Project **7 Warwick Court**

Drawing Title: **Demolition Front Elevation**

Drawing No. **D_07** Rev. **D**

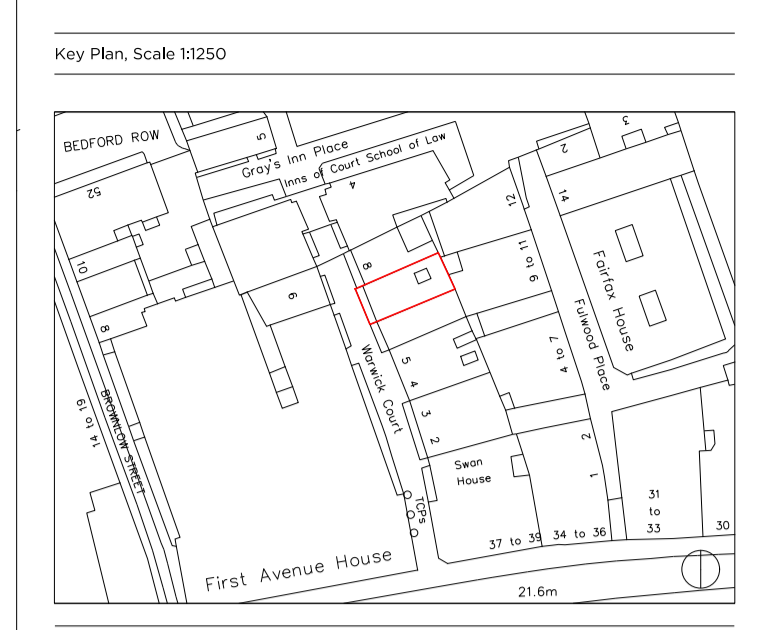
- C. Revision Note:**
- C.1 Existing roof finish & structure to be retained and reinstated.
 - C.2 Existing dormer windows to be retained.
 - C.3 Rafting and lightwell stair to remain in existing position.
- D. Revision Note:**
- D.1 Demolition of wall to allow for airbrick (219x140mm)
